SERVICE INFORMATION NO. SI 42-049

GARMIN - Service Bulletin No. 0736

SERVICE BULLETIN

G1000 System ID Tool

Figure 1. Example AUX - System Status Page

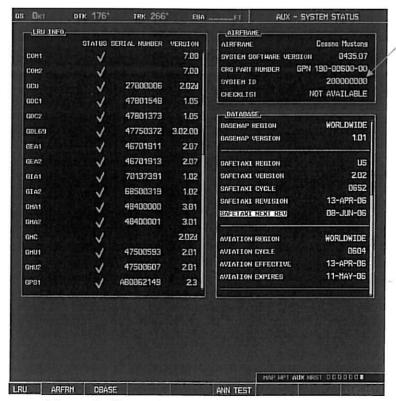
PURPOSE

All GDU 1XXXs with a System ID of "00000000" or "20000000". The G1000 System ID can be verified on the MFD AUX-System Status Page (Figure 1).

- Verify the System ID is not "00000000" or "20000000" on the MFD AUX-System Status page.
- Verify optional features (TAWS, ChartView, etc.) are active.
- · Verify no database errors exist in the ALERT window.
